FACILITY: Peach Bottom Atomic Power Station, Units 2 and 3

SUBJECT: SUMMARY OF MEETING WITH PHILADELPHIA ELECTRIC COMPANY PROPOSED
SAFETY PARAMETER DISPLAY SYSTEM (SPDS) AT THE PEACH BOTTOM FACILITY

FIGURE 1

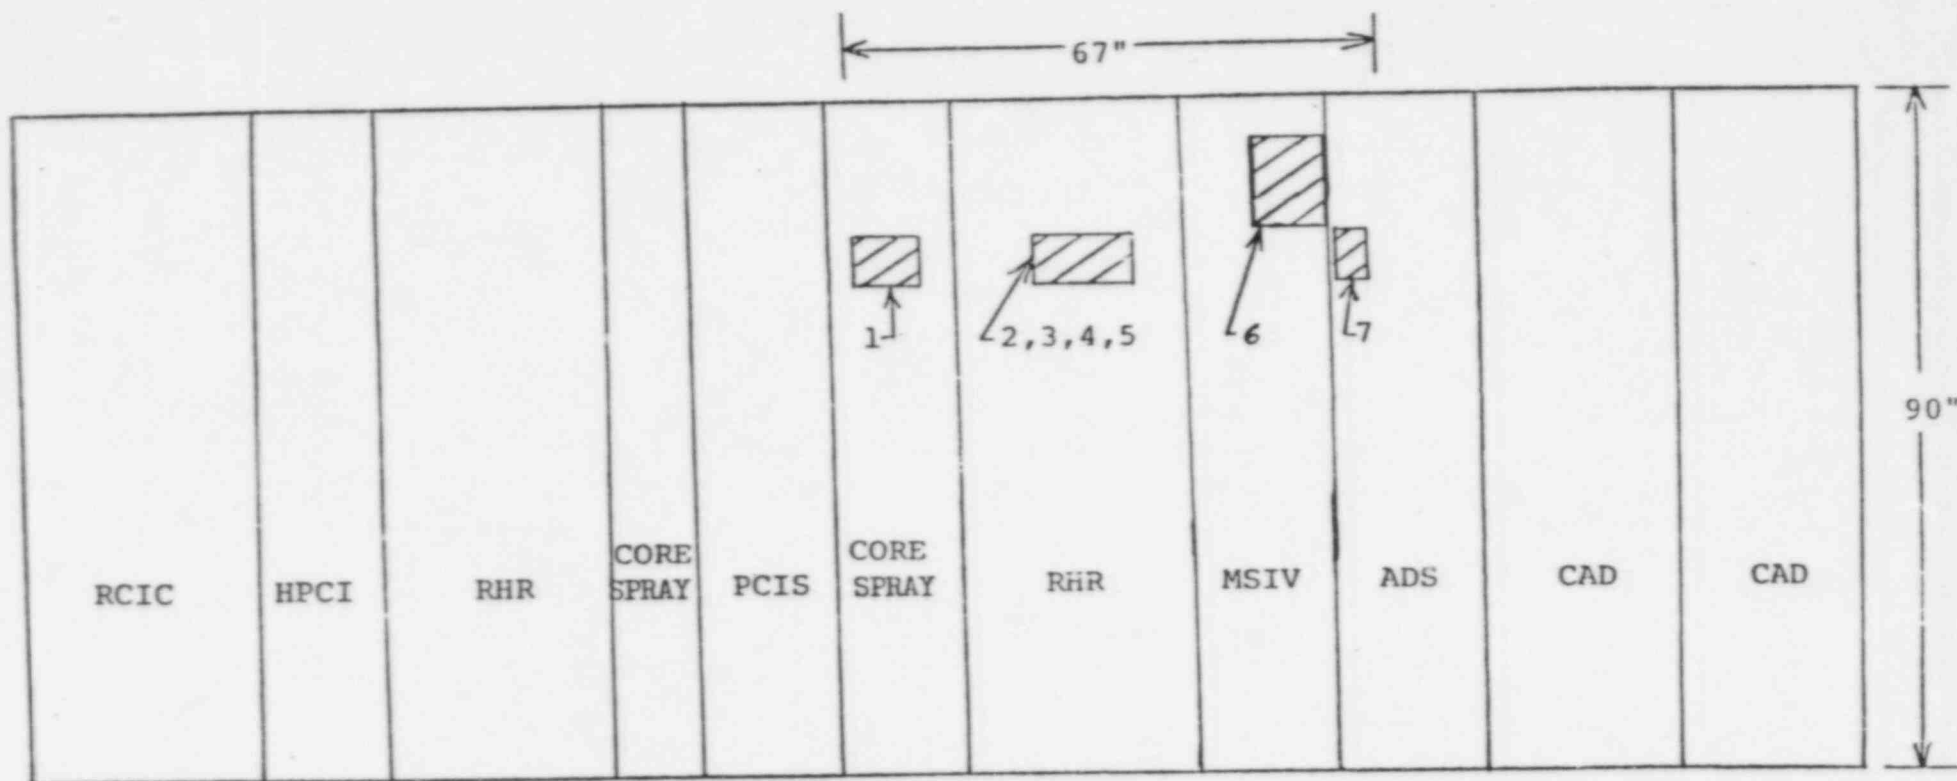
*USES STRIP-CHART RECORDERS AND
VALVE POSITION LIGHTS AT TWO
LOCATIONS

*HIGHLY RELIABLE INDICATION

*VARIABLES SELECTED ARE TRIP

ENTRY CONDITIONS

*FULLY OPERATIONAL AFTER REACTOR
PRESSURE INDICATION ADDED

*CRDR TO PROVIDE ENHANCEMENTS
-NEW LABLES
-INDICATORS COLOR CODED
-OUT-OF-NORMAL LIMITS
COLOR CODED

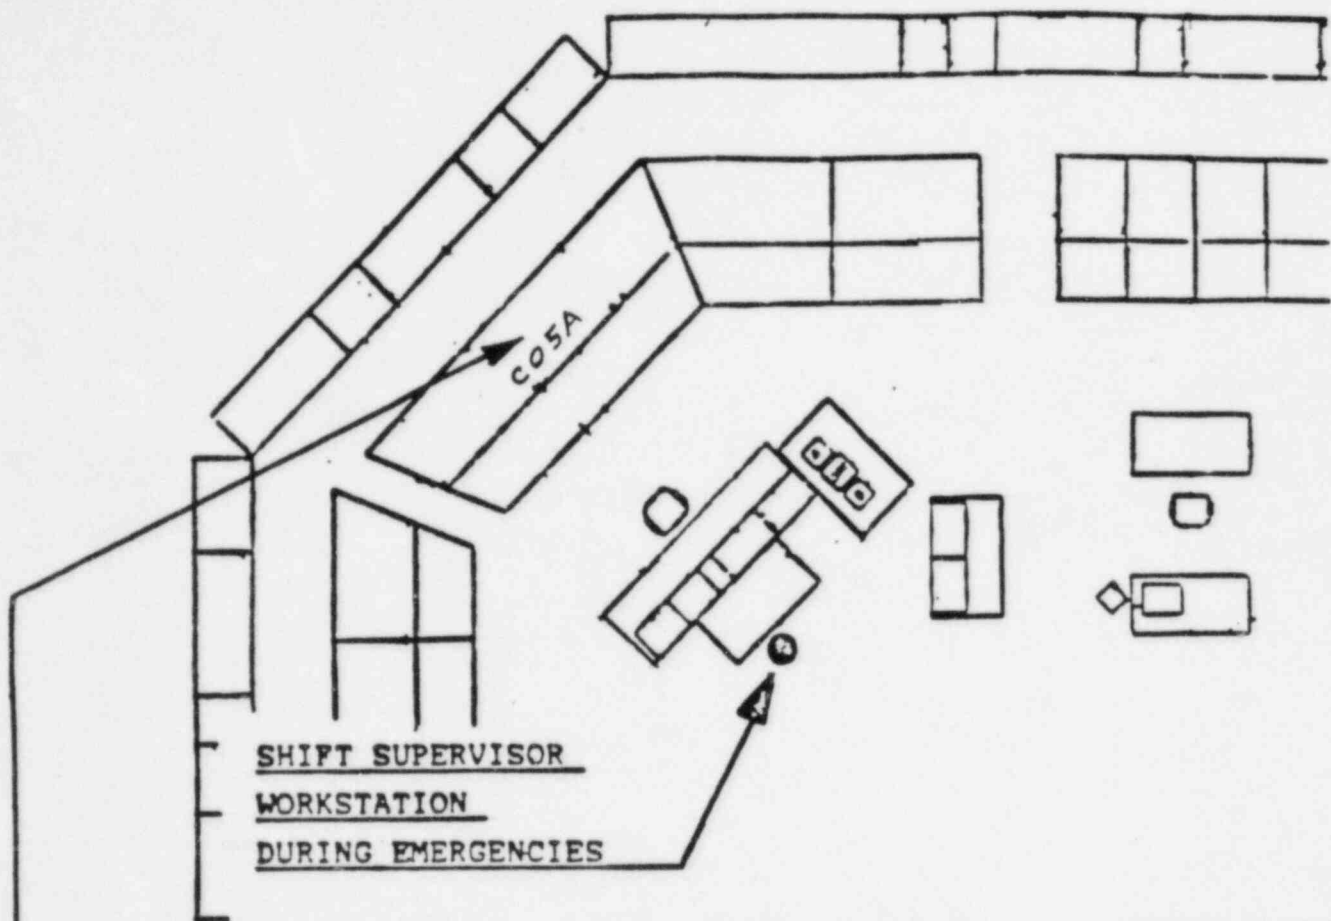
*PLANT UNIQUE IMPLEMENTATION

- OPERATOR AT PANEL C05A
CONTROLLING REACTIVITY
- OPERATOR AT PANELS C04B AND C,
C03, C484A AND B CONTROLLING
ECCS
- SHIFT SUPERVISOR IN MIDDLE OF
ROOM RECEIVING DATA AND
LOOKING AT PROCEDURES
- STA HAS ACCESS TO DATA
- DISPLAYS ARE CONCISE FOR USER
- SIMULATOR EXPERIENCE SHOWS
THIS WORKS WELL

- REQUIRES MORE CONCISE DISPLAY
- REQUIRES SHIFT SUPERVISOR TO
GATHER DATA
- APPEARS TO IMPOSE NEW
REQUIREMENT
